**LIST OF FIELD MODIFICATIONS**

**WASP 985 AN-5, -14B ENGINES**

(This EO replaces EO 10A-10AA-6A dated 13 Nov 63)

Figure 5 (Issue 2)

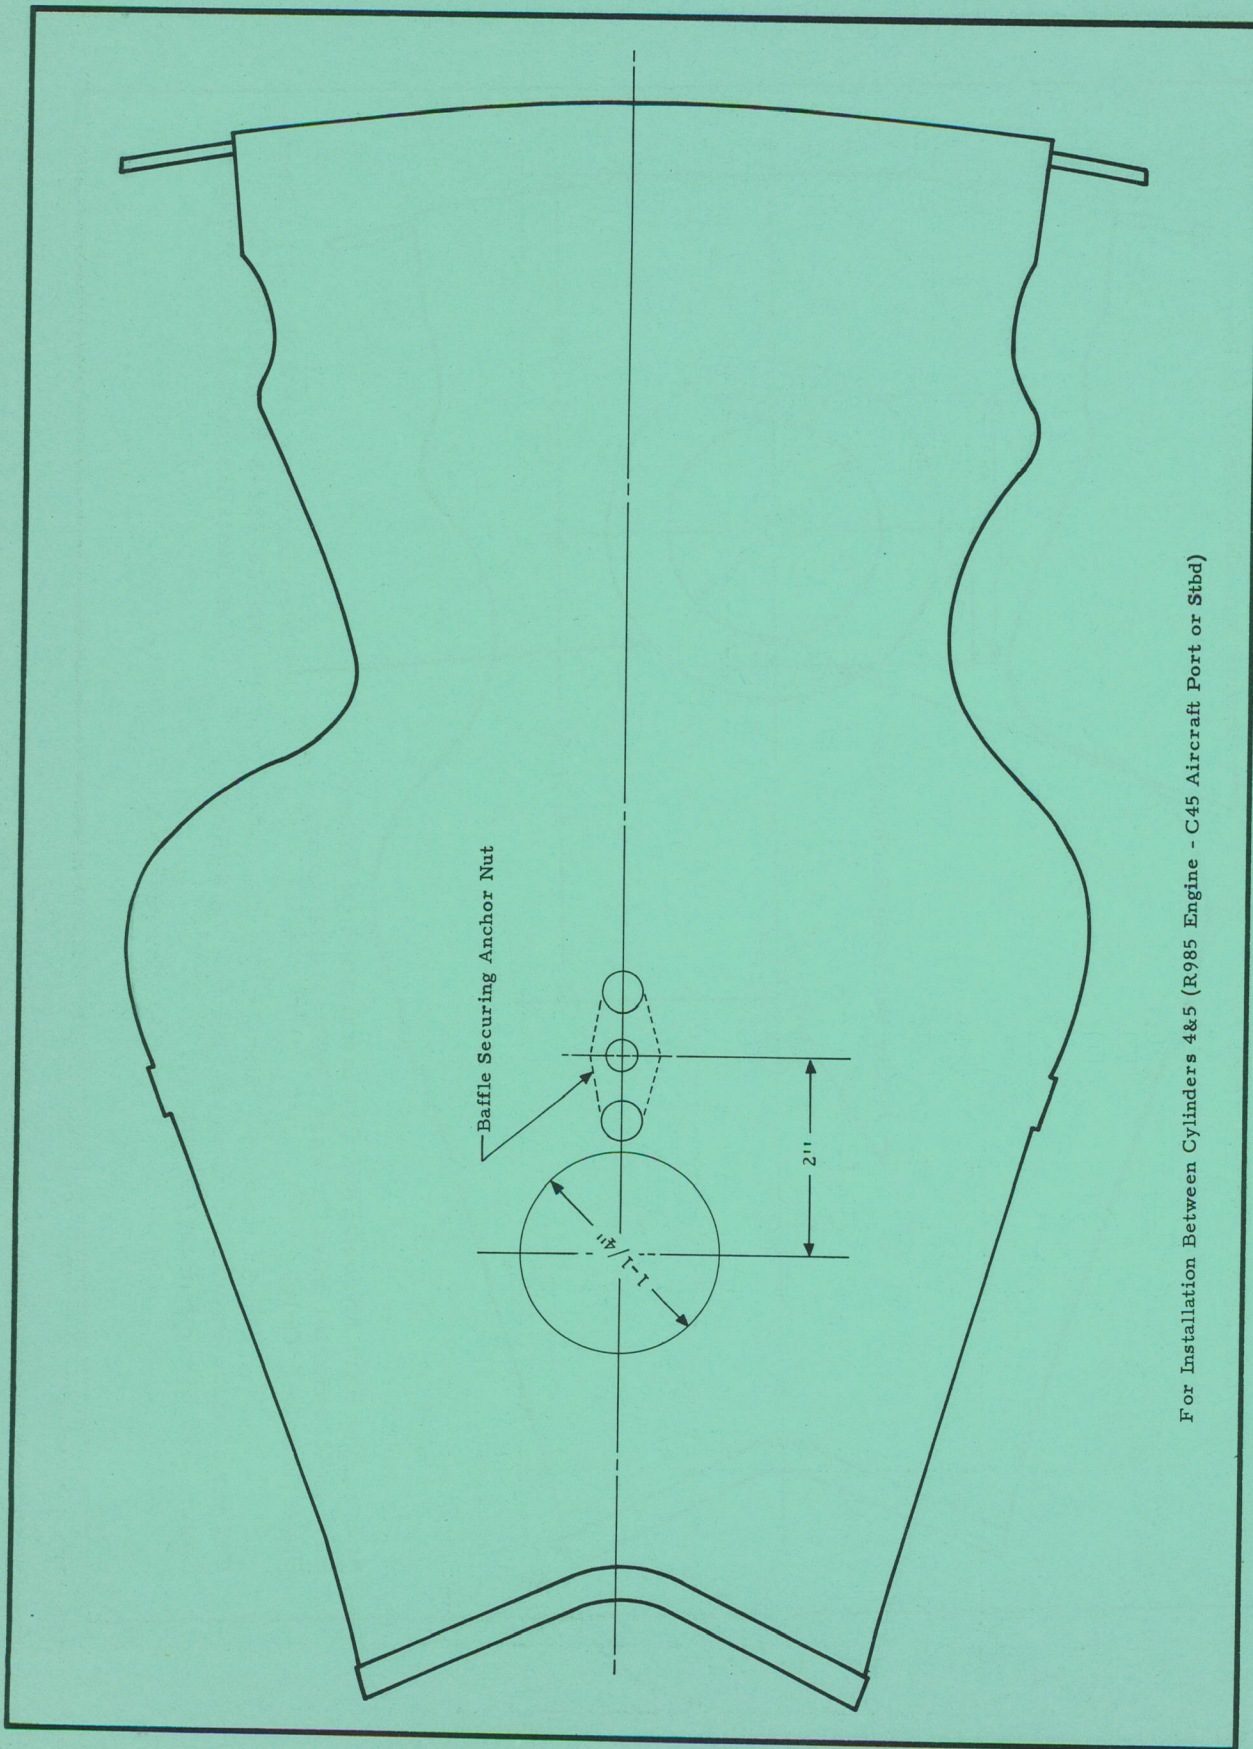
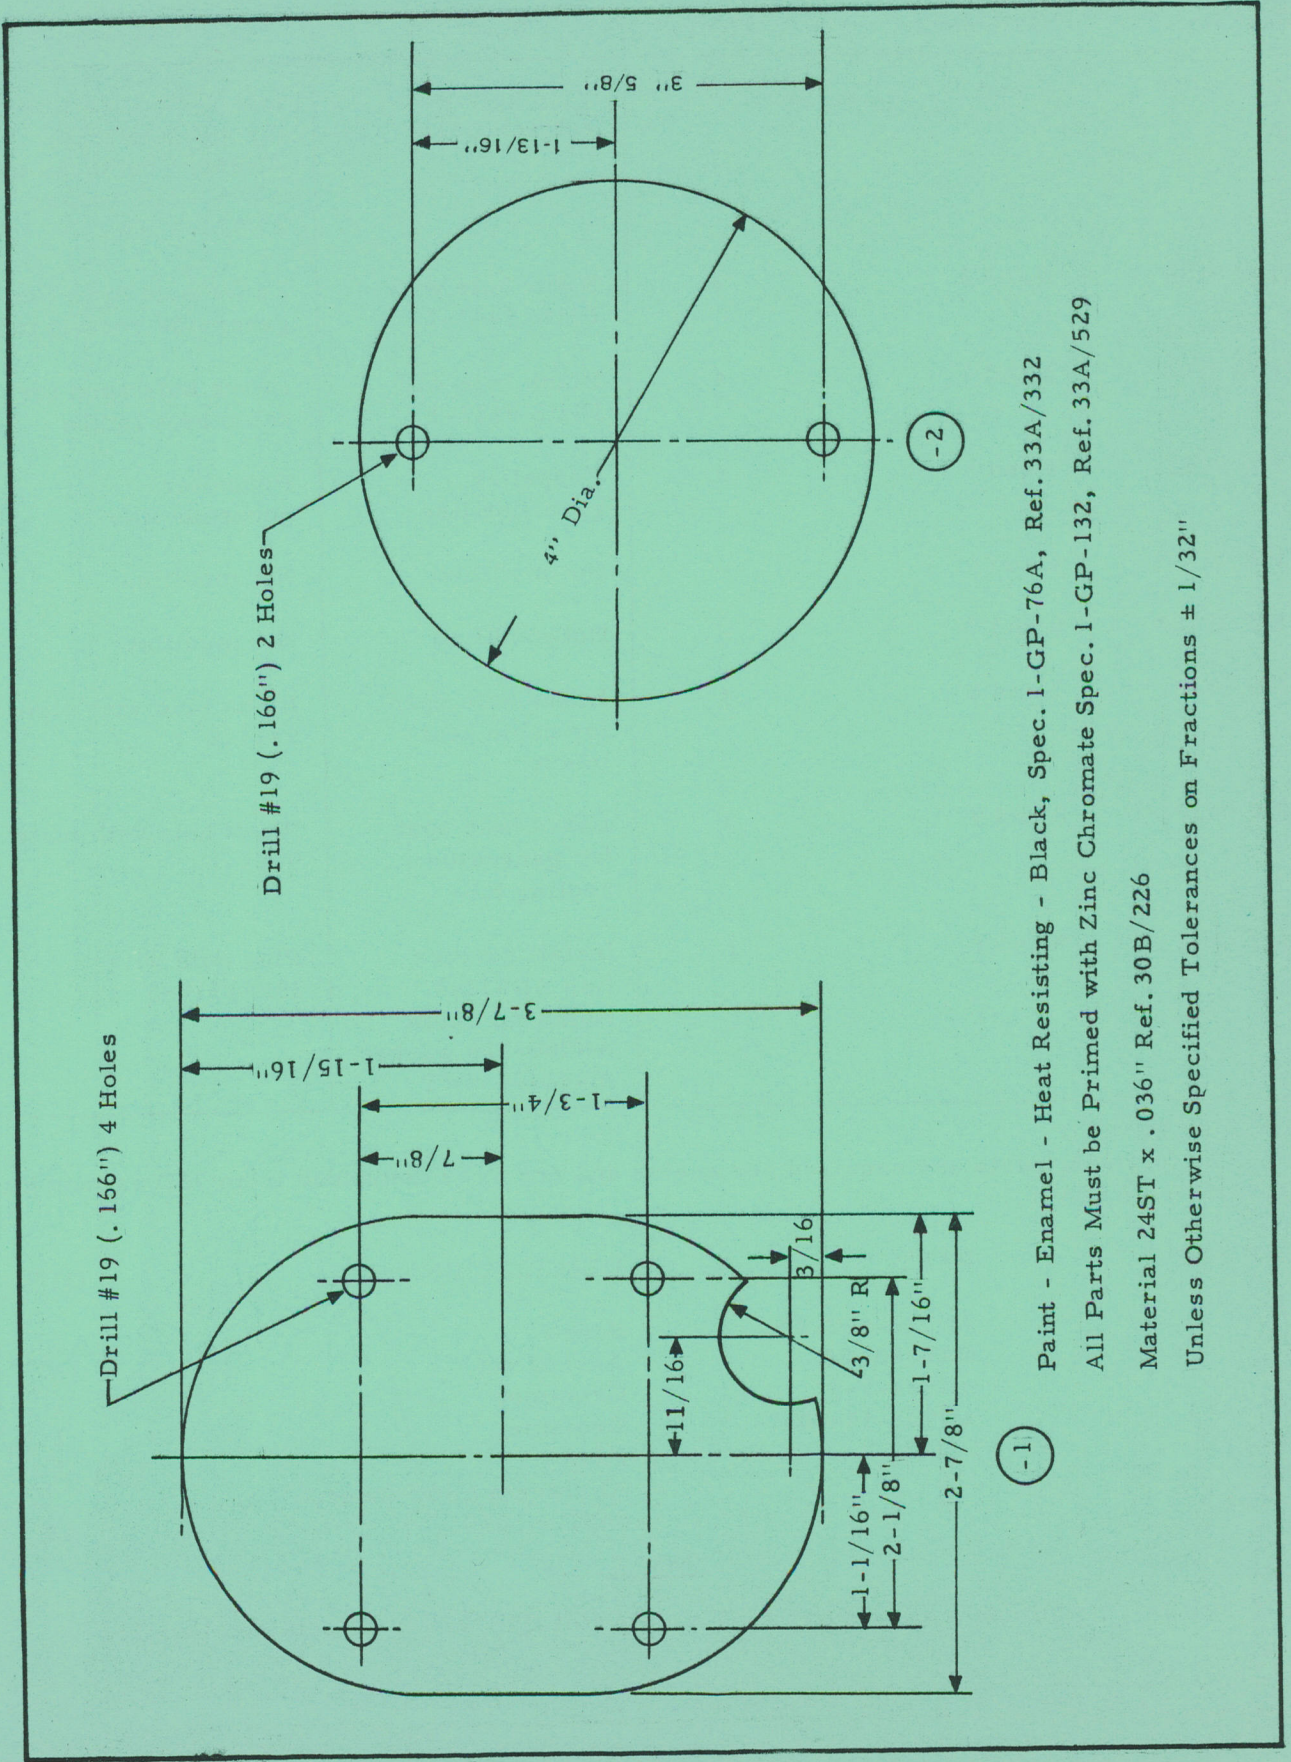
- (c) Remove intercylinder baffle Part 39988 from between cylinders 2 and 3 and rework to Part CPW 9438 as per Figure 2.
- (d) Remove intercylinder baffle Part 39986 from between cylinders 8 and 9, blank off existing hole and rework to Part CPW 9442 as per Figure 5.

For Installation Between Cylinders 4&5 (R985 Engine - C45 Aircraft Port or Stbd)

Figure 1 (Issue 1)

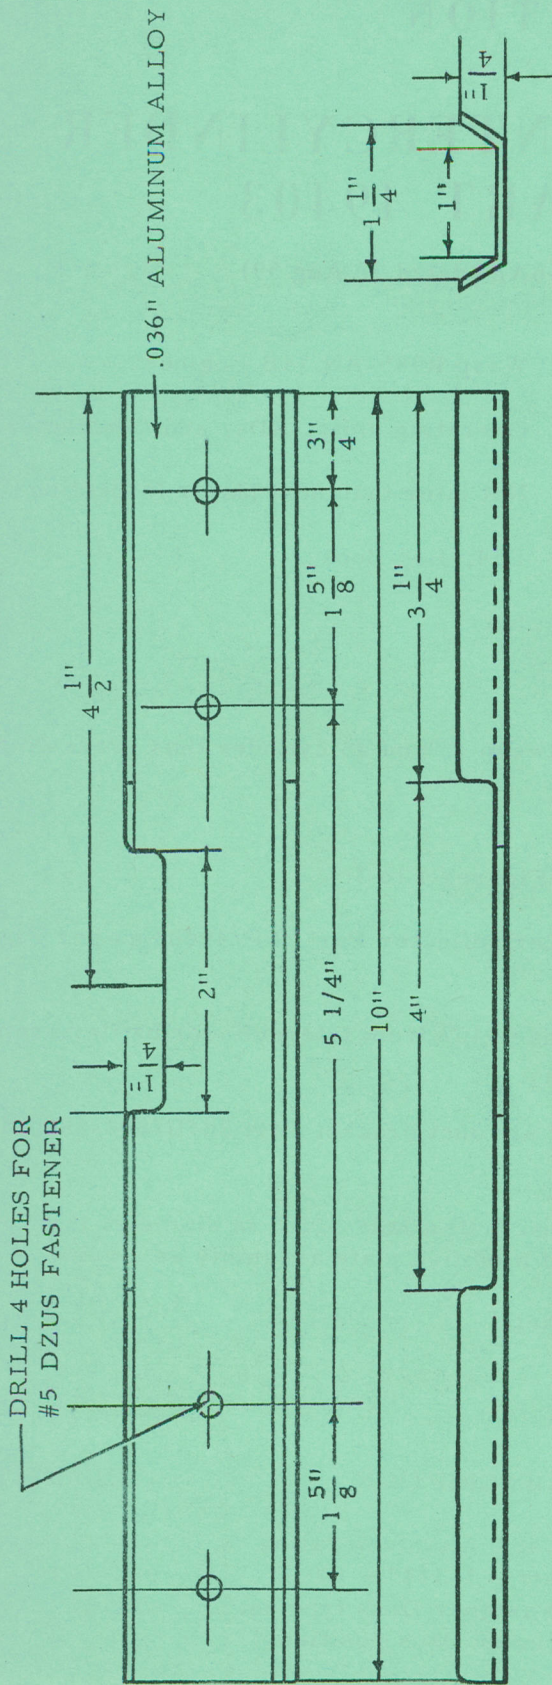
- (a) Construct modified plate assembly intercyylinder deflector Part 36P/49403 as per Figure 1.
- (b) Remove latches and spring Part 36P/49406 and 49407 from intercyylinder baffle assembly 36P/71538.
- (c) Remove wedge type anchors from carburettor air duct bracket Part 26JU/804-189061 RH and 26JU/804-189062 LH.
- (d) Place modified plate assembly into position and drill a hole 5/16" in diameter through centre base of each bracket using the outside holes of modified plate assembly as a guide.
- (e) Install spring for Dzus fastener on each bracket.

1. CONSTRUCT MODIFIED PLATE ASSEMBLY - INTER CYLINDER DEFLECTOR PART 49403 AS SHOWN
2. USE ALUMINUM ALLOY 24ST, SEC./REF. 30B/226
3. SURFACE TREATMENT - ZINC CHROMATE PRIMER REF. 33A/462, MIL-P-6889A
4. FINISH WITH BLACK ENAMEL PAINT REF. 33A/332, SPEC. 1-GP-76-LPO

ALL RADII 1/8" UNLESS OTHERWISE SPECIFIED

Figure 1 (Issue 1)

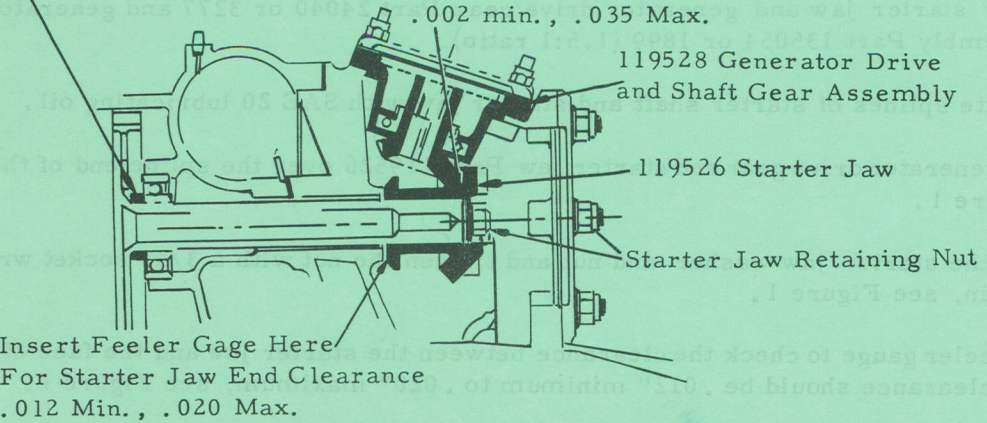
- (a) Remove starter jaw and generator drive gear Part 24040 or 3277 and generator housing shaft gear assembly Part 135054 or 1899 (1.5:1 ratio).
- (b) Lubricate splines of starter shaft and starter jaw with SAE 20 lubricating oil.
- (c) Install generator drive gear and starter jaw Part 119526 over the spline end of the starter shaft, see Figure 1.
- (d) Install the starter jaw washer and nut and tighten the nut with a 3/4" socket wrench and install cotter pin, see Figure 1.
- (e) Use a feeler gauge to check the clearance between the starter jaw and the face of the gear\* bushing. This clearance should be .012" minimum to .020" maximum, see Figure 1.
- (f) Install the generator drive gear assembly Part 119528 in position in the rear section. A rubber oil seal Part 31123 is required between the flange of the generator bearing housing and the mounting pad of the rear section, see Figure 1.

- (g) Check the backlash between the generator drive gear and the starter jaw gear using a dial indicator and PWA 2003 arbor. First check the backlash with the starter jaw as far forward (towards the power section) as possible and again with the starter jaw as far to the rear as possible. In the forward position the backlash should not be less than .002". In the rear position the backlash should not exceed .035", see Figure 1.
- (h) Tighten the four nuts on the generator drive cover and lockwire the nuts.
- (j) Replace the starter and generator in the normal manner.

Check Starter Jaw Generator Drive Gear Backlash With Dial Indicator and PWA 2003 Arbor  
 .002 min. , .035 Max.
